## **PLAN REVIEW SHEET**

2013-043

Novant Health, Inc.

**Concrete Pad Spec**

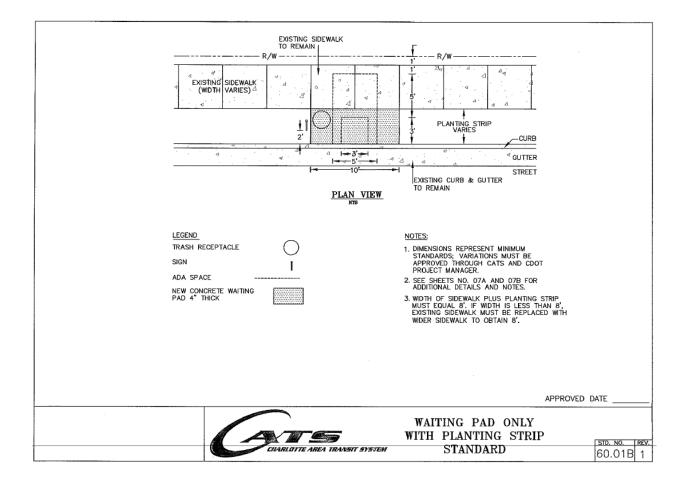
We request that the Petitioner provide a waiting pad for bus service along East 4<sup>th</sup> Street. The pad may be located beneath the possible future pedestrian bridge near side of the driveway following existing Barnette Place.

The concrete waiting pad would be located between the existing curb and the new sidewalk. Pad must be flush with sidewalk and level within 2% when measured perpendicular to street for compliance with the ADA. Below is an image of the standard (60.01B) detail.
